BREAKERS
HOTEL
RENOVATION

Breakers Hotel Elevator Tower Height Increase Request

Breakers Hotel Window System Approval
November 7, 2019

SHEET NUMBER
A5.03
 EAST ELEVATION

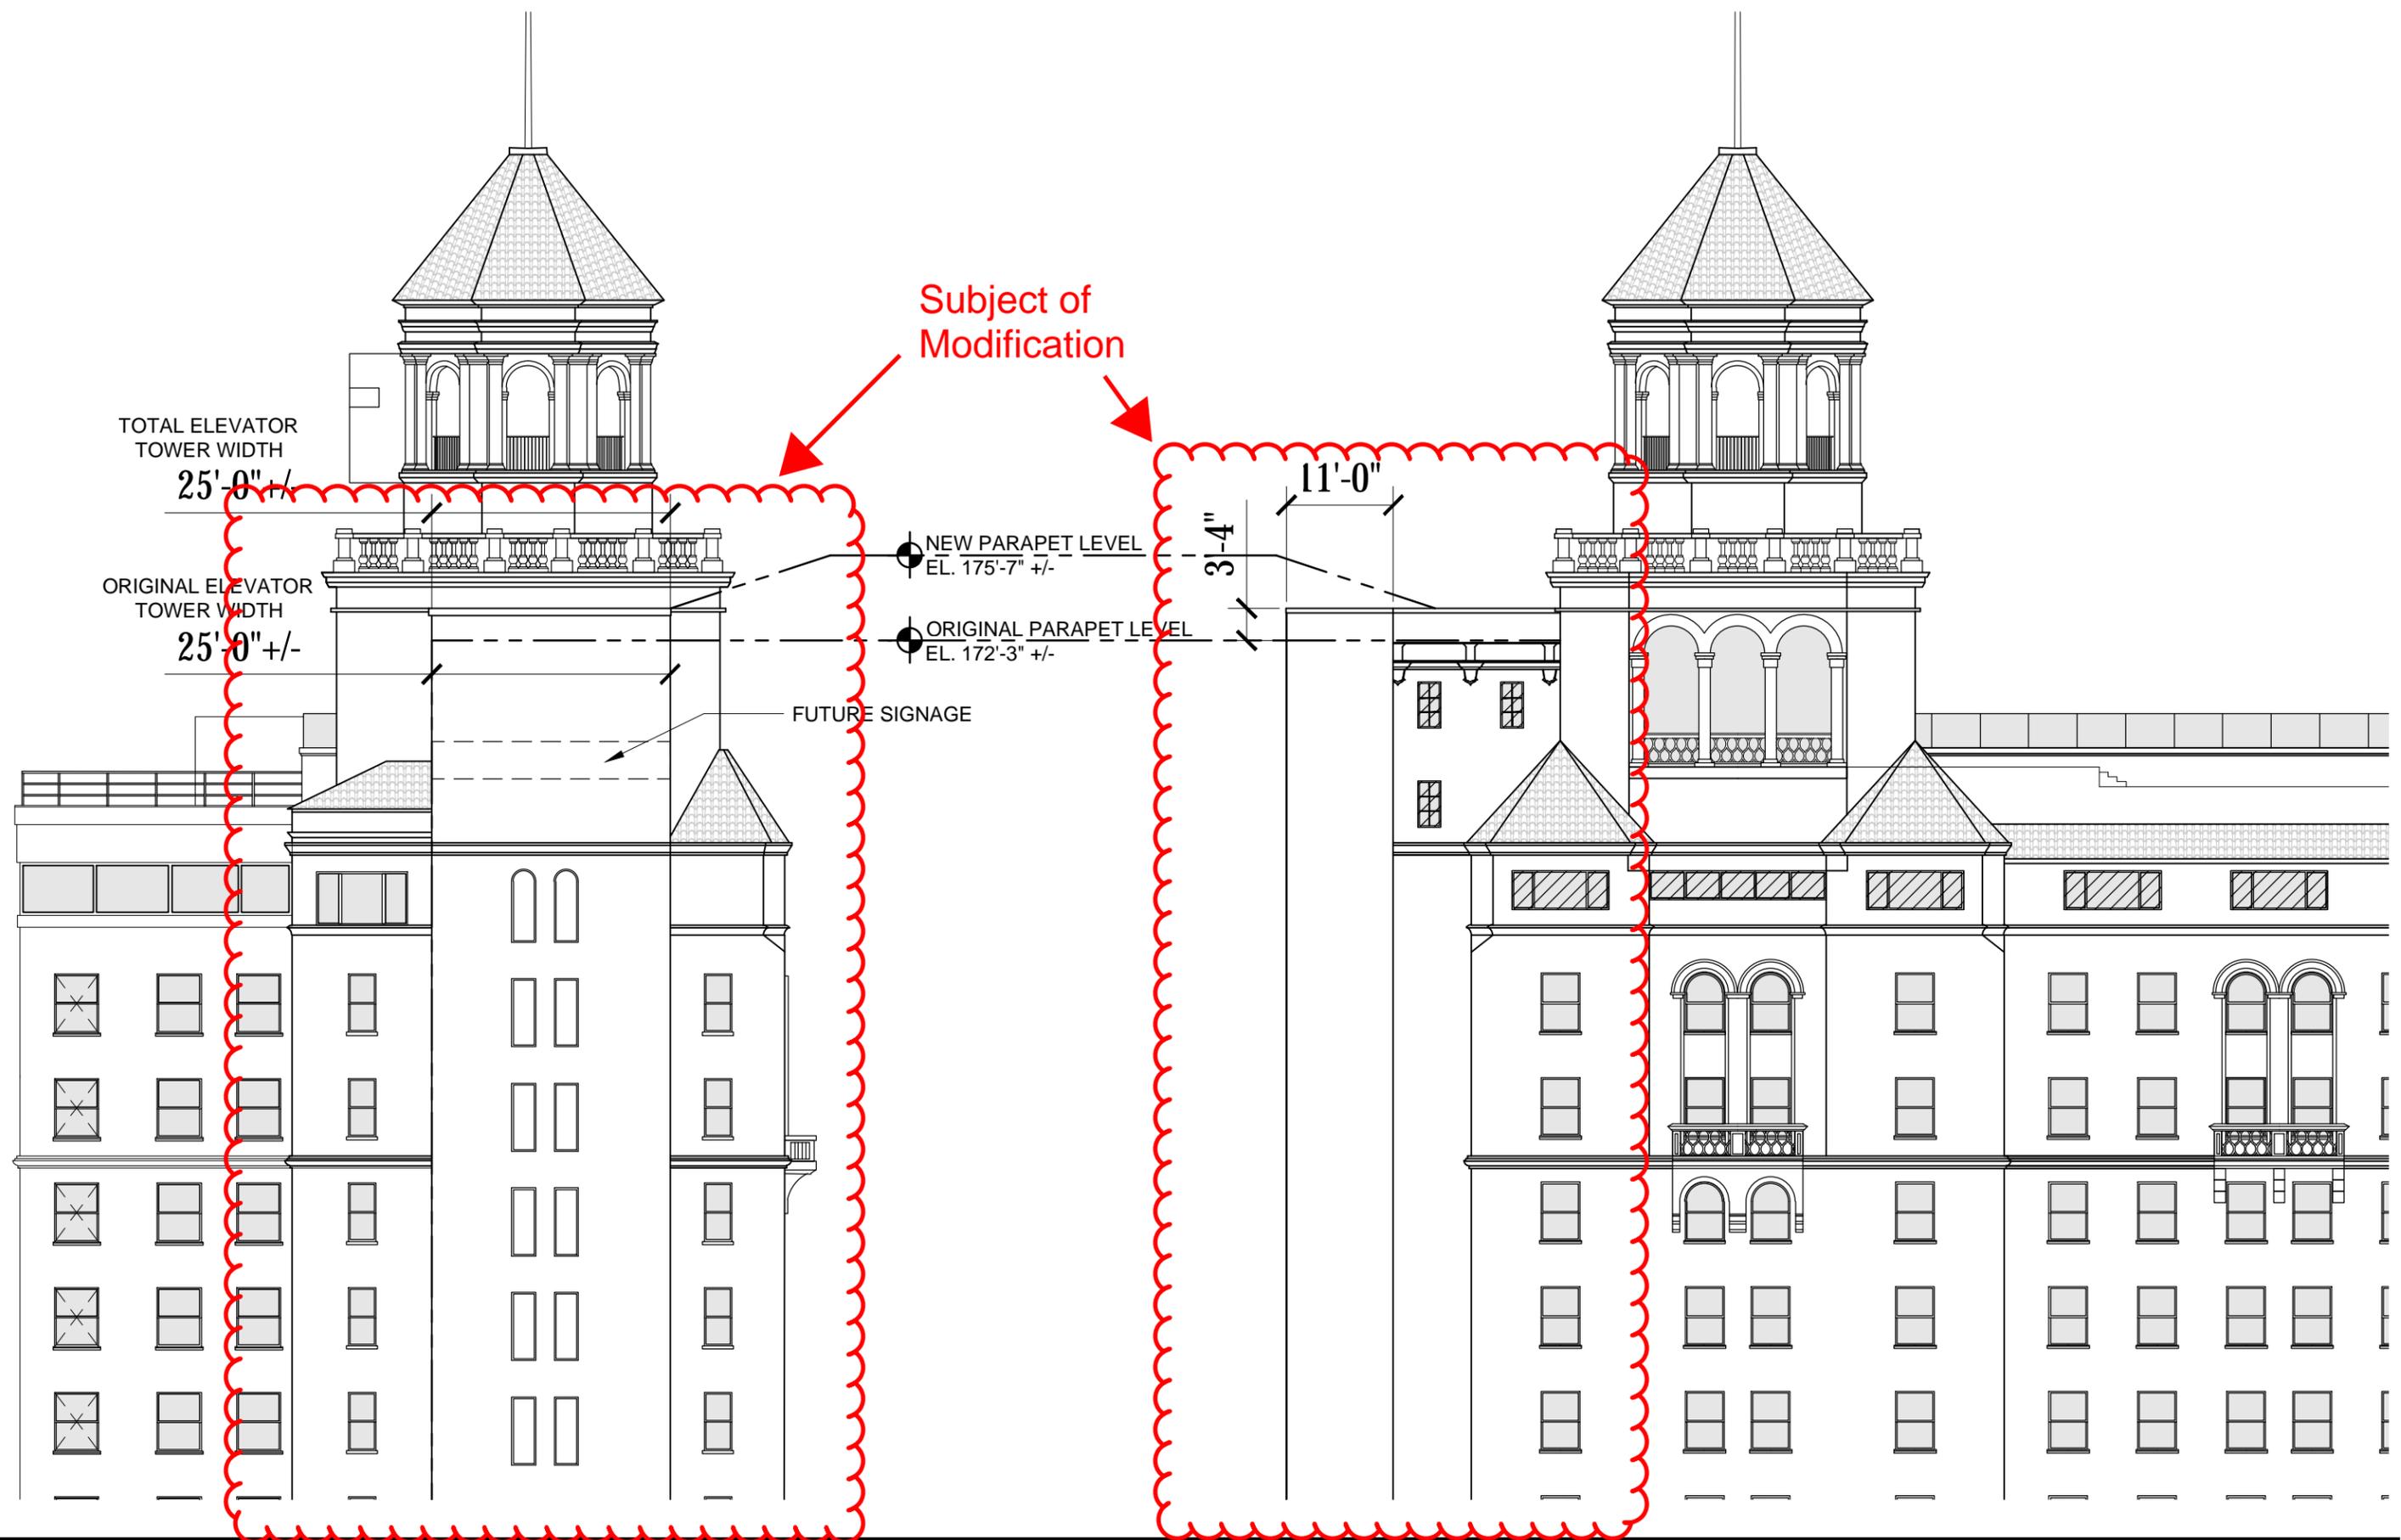
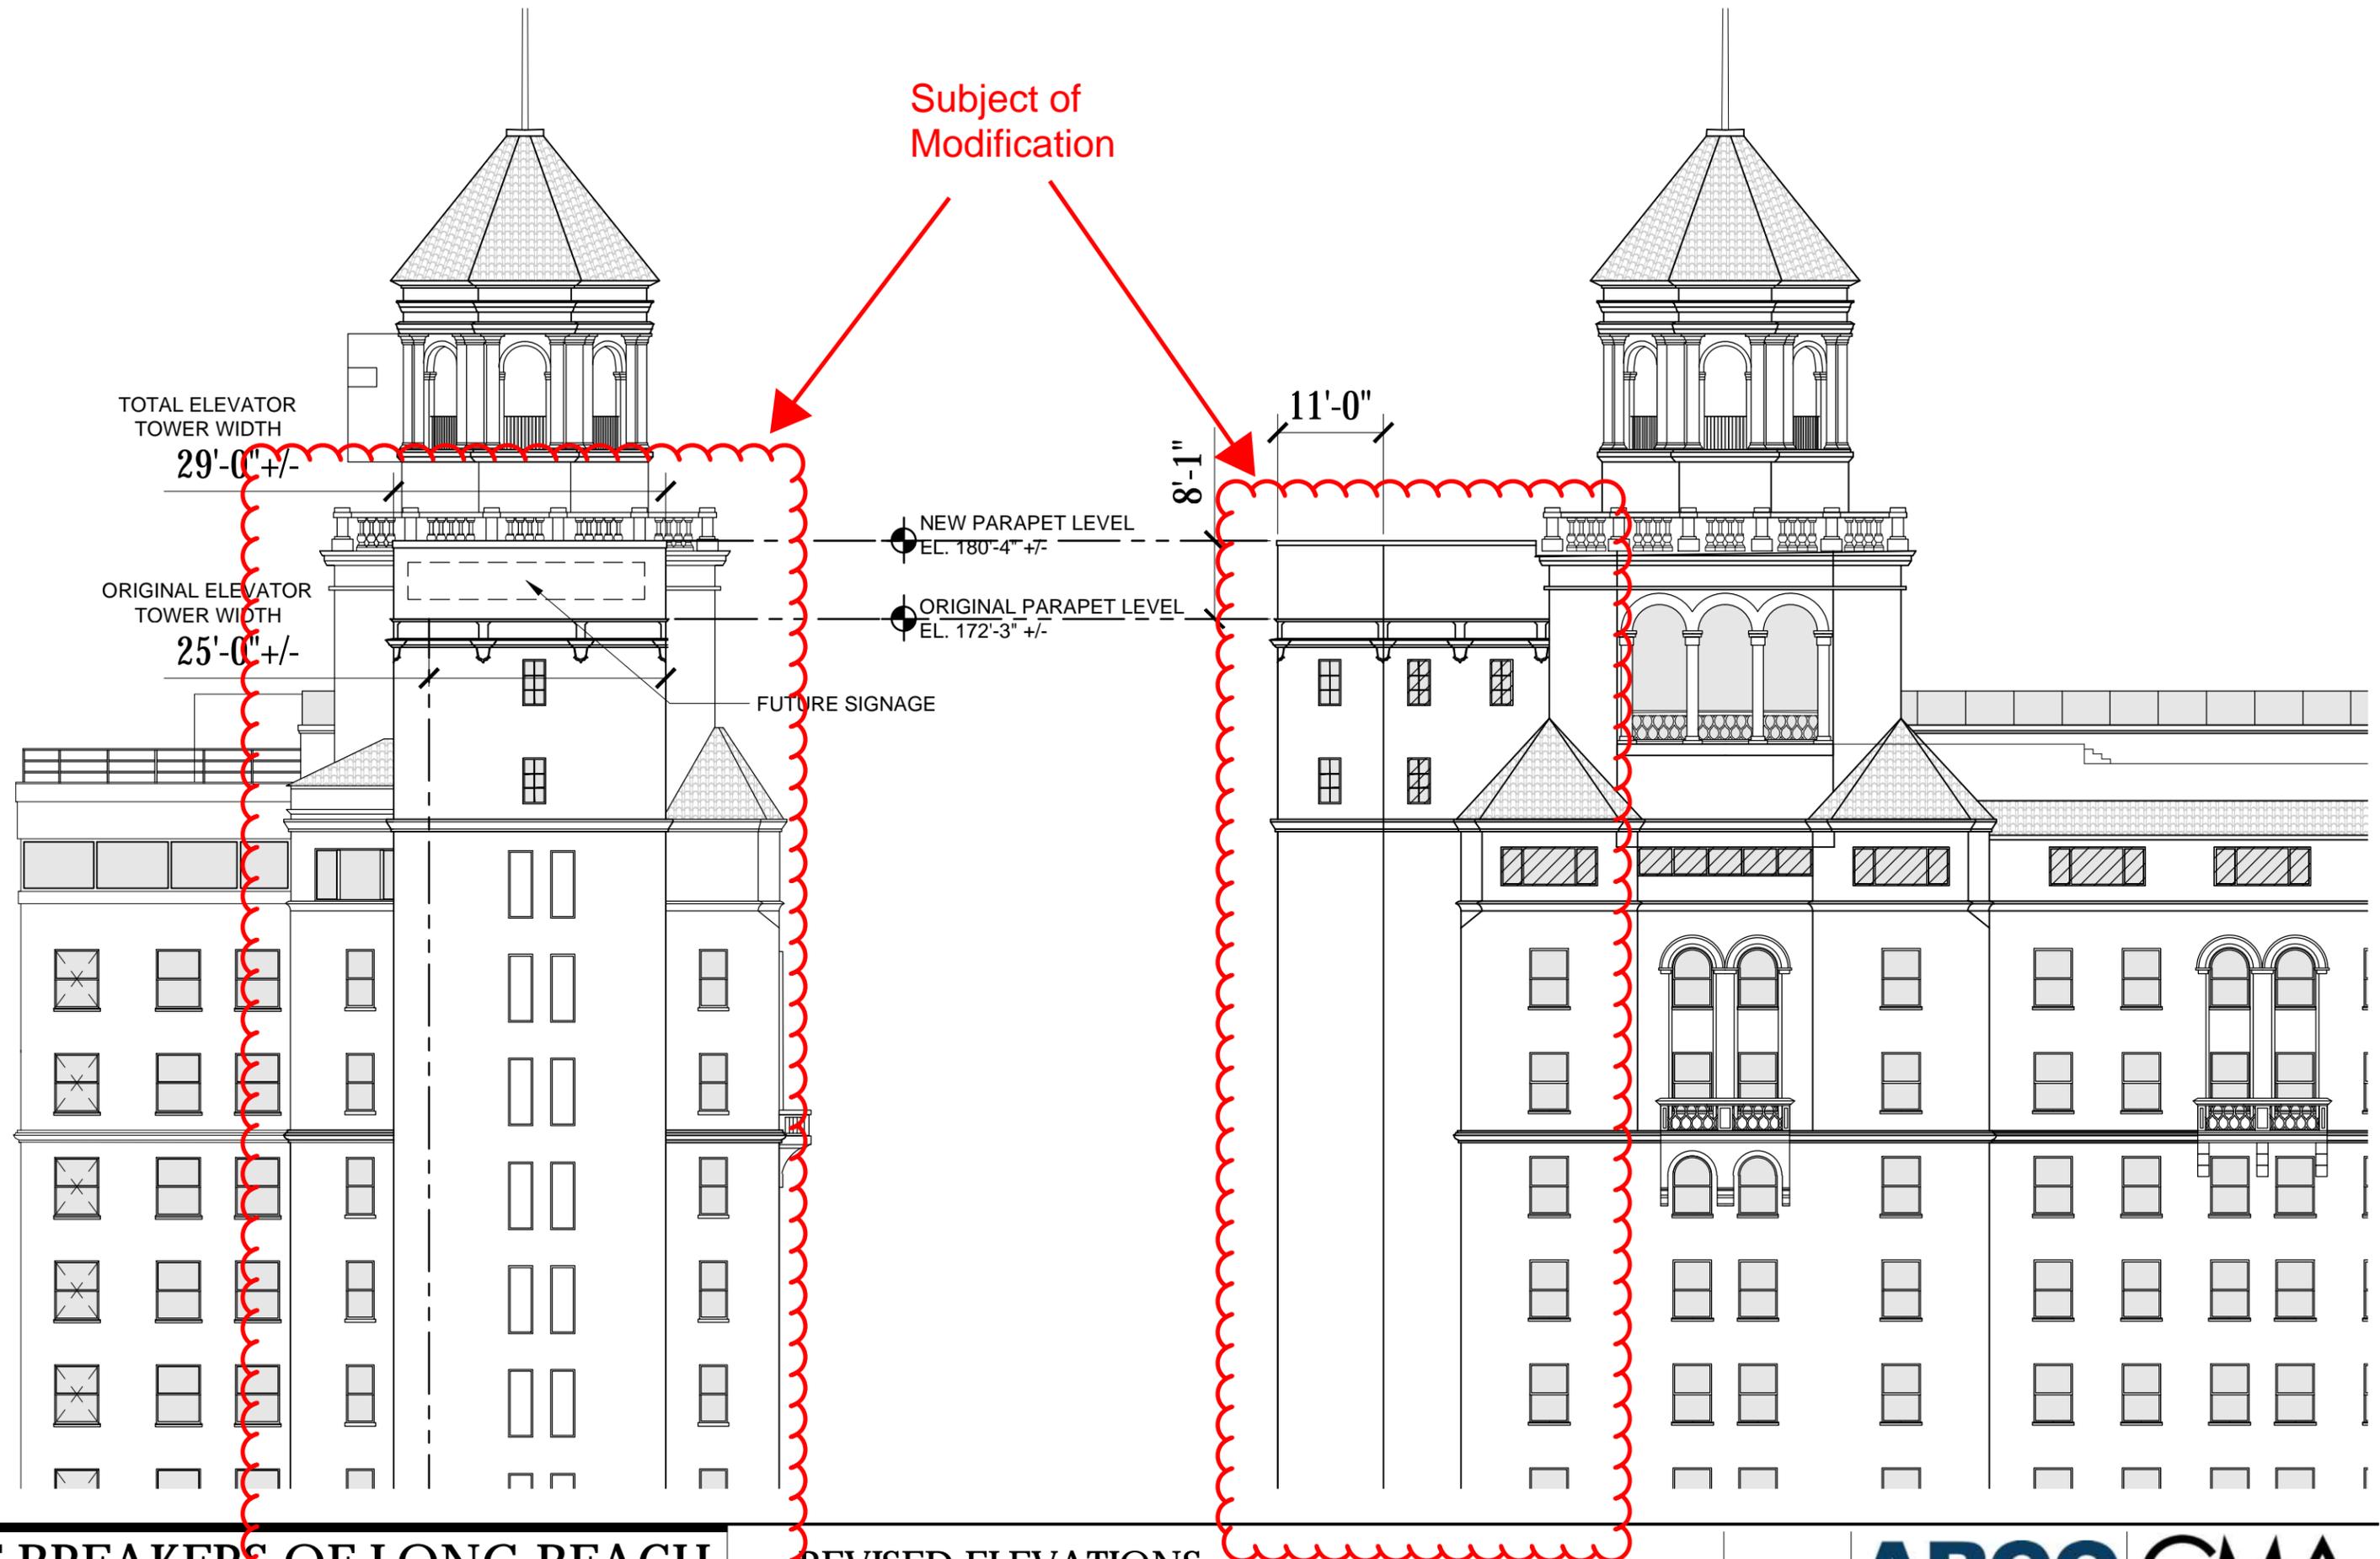
Subject of Modification

NEW PARAPET LEVEL
EL. 175'-7" +/-

ORIGINAL PARAPET LEVEL
EL. 172'-3" +/-

3'-4"
11'-0"

- 1.) approve the necessary tower height increase that would allow us to install these critical life safety systems,
- 2.) approve the incorporation of façade detailing (cornices, windows, moldings) on the new tower element as shown on the new design.
